**RE: ConAgra Foods, Inc.  
Storm Water Compliance Inspection  
Permit 1GR01005\*EG**

# Industrial Storm Water Reconnaissance Inspection Report

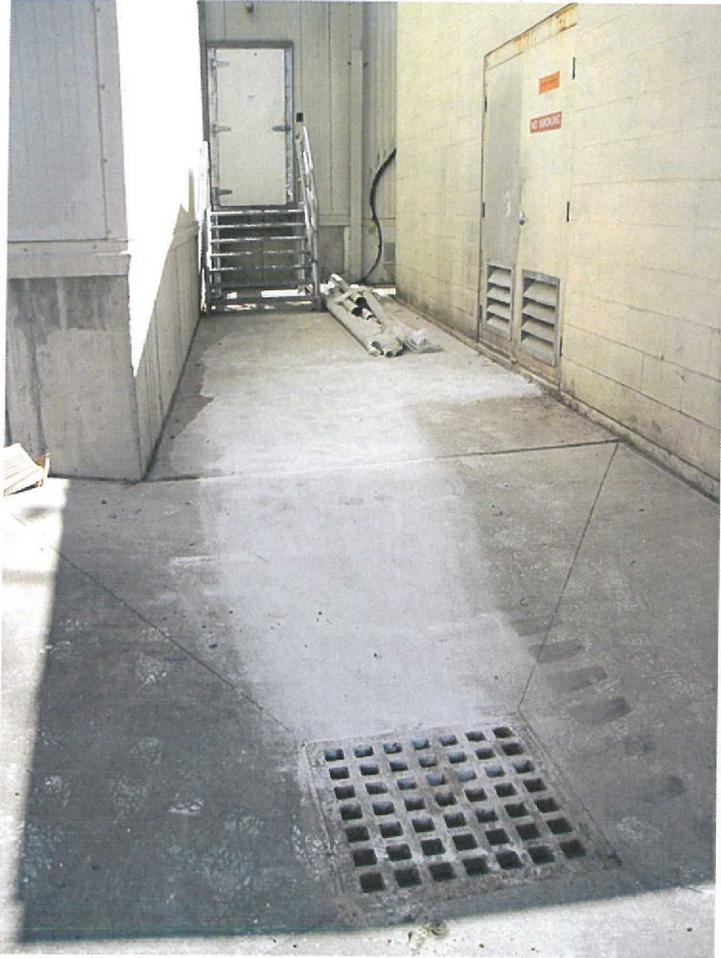
***From what I could see, all industrial stormwater from the site enters the detention basin.***

*Catch basin next to flour sifter building*

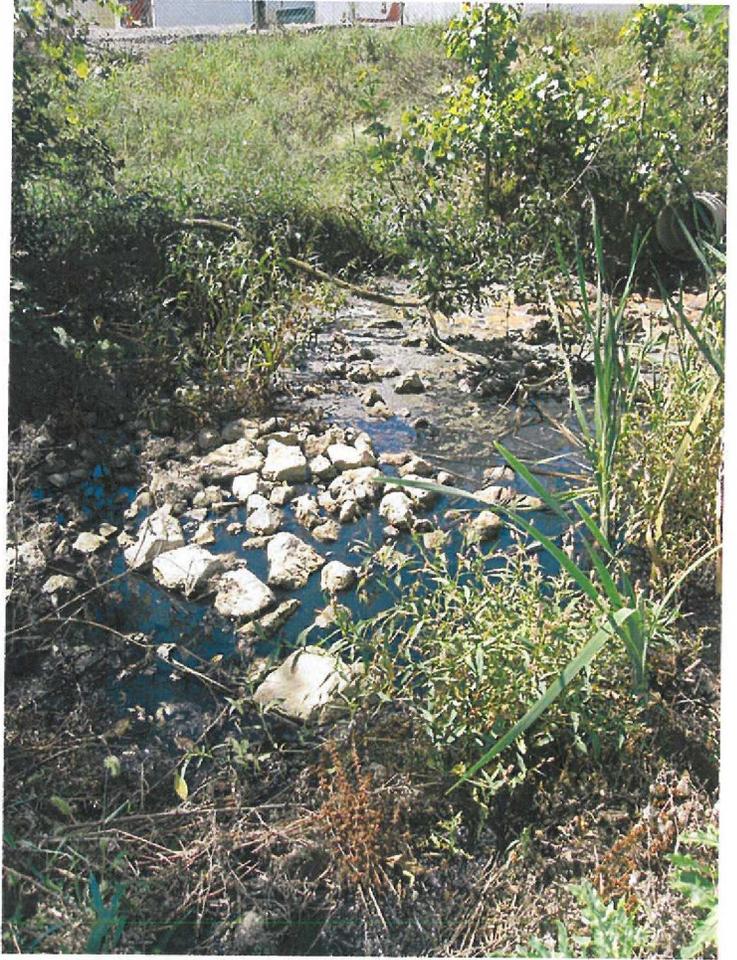
***Food ingredients are not compatible with exposure to stormwater. There was evidence of fugitive flour from the sifter building getting into a catch basin and the retention pond was septic with what ConAgra now believes was flour (see pictures)***

If yes, describe: ***Flour from sifter building (see picture). Also, water in detention basin was septic.***

***Black stagnant water in detention basin  
(no flow into basin at the time)***
